Texas Star DX1600V

Driver Chassis

Copyright © 2006, CBTricks.com All Rights Reserved Rev. #1.9

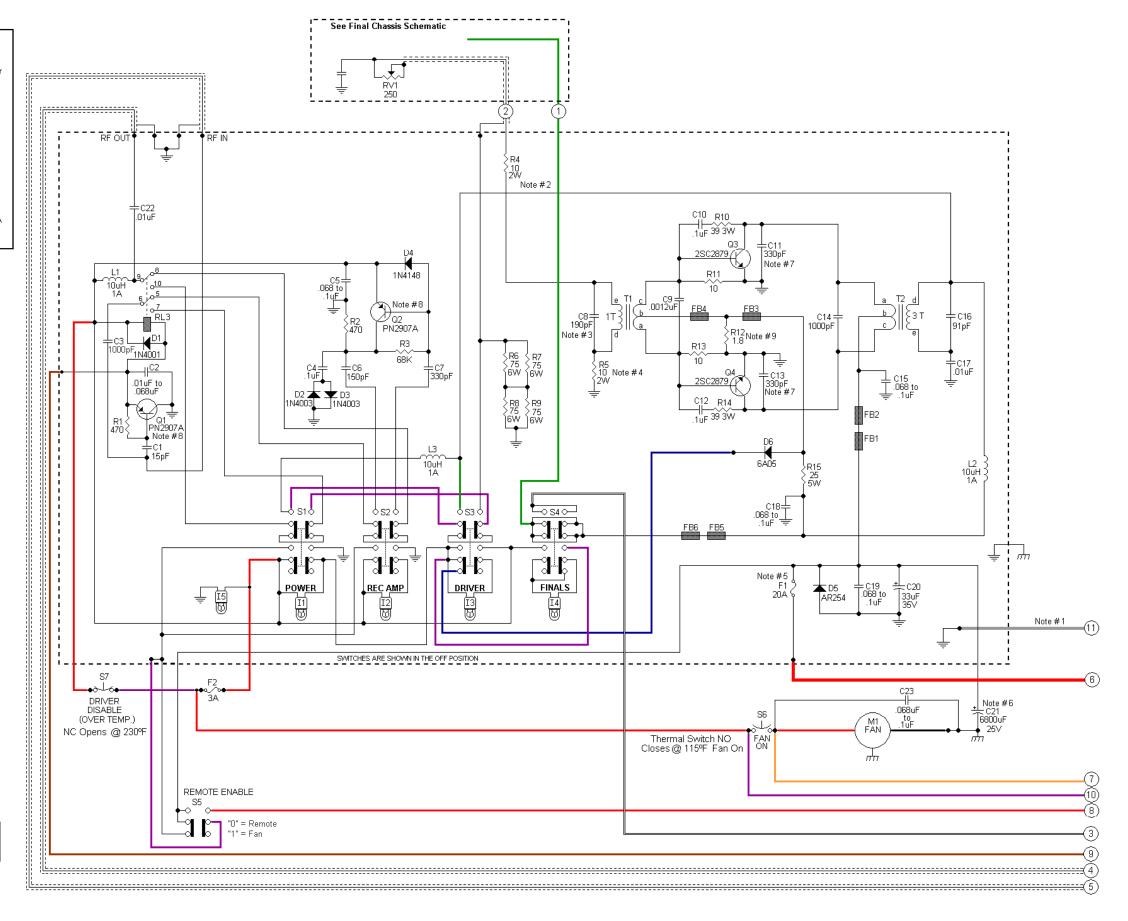
3. C8 was changed from 470pF to 190pF Silver Mica

4. Wire lead "d" T1. is connected to a 10 ohm 2W to

Driver PCB ground. (R5)

5. F1 was changed from 30A to 20A ATC fuse.

6. C21 was changed from 2200uF 35V to 6800uF 25V

7. Added C11 and C13 330pF

8. Q1 and Q2 where changed from 2N4125 to PN2907A

9. R12 was changed from 1.6 ohm to 1.8 ohm
